Re: Residential Development at Scholarstown House, Scholarstown Road, Dublin 16
Register Reference: SD22A/0401

Discussion have taken place with Graham Murphy Transportation Engineer SDCC on 03rd February 2023. Following receipt of the request for further information dated 16-12-22 I would like to address the Traffic & Transportation issues raised in item 7,

Figure 5: 30 km/hr Slow Zone speed limit north of Site Access

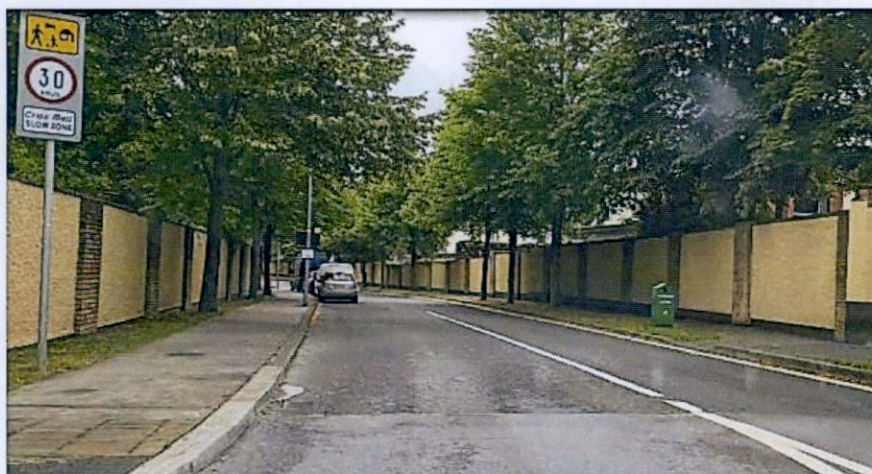
The proximity of access to the Scholarstown Road roundabout may present risks. There is a raised pedestrian crossing at the access. To achieve the sight lines when exiting the development motorists will need to stop closer to the intended stop line, this will mean stopping on the pedestrian crossing. There is no elevation detailing the access location, a detailed visibility splay is required to ascertain if boundary treatment, street trees etc will limit forward visibility from the development. The road safety audit notes that on street parking on one side of Orlagh Grove if allowed to continue will obstruct visibility to and from the development and compromise safe unobstructed two-way movement on the road. The proximity to the access point of the neighbouring retail units could cause visibility issues when used simultaneously leading to traffic hazard. Because of the nature of the neighbouring retail units, they would have a high frequency traffic use, resulting in an increased risk. The applicant is requested to move the proposed access location away from the other access or provide some mitigation to reduce the frequency of use of the other access.

We are looking to maintain the existing entrance location as to move the entrance would involve a significant redesign of the apartment complex. The first point to establish is the speed limit on Orlagh road at this location is 30kph see extract from Road Safety Audit below.

The appropriate junction sight distance is 24m measured at 2.4m back from the road edge to the north and road centreline to the south in accordance with the Design Manual for Urban Roads and Streets for a design speed of 30km/hr.

Drawing SH-DA-P01 Rev03 & SH-DA-P02 Rev03 attached shows the junction sight distance of 24m. I have also moved the raised pedestrian crossing back from the junction to provide a level area for a car off the raised crossing. Double yellow lining has been added over the extent of the junction sight distance to prevent illegal parking.
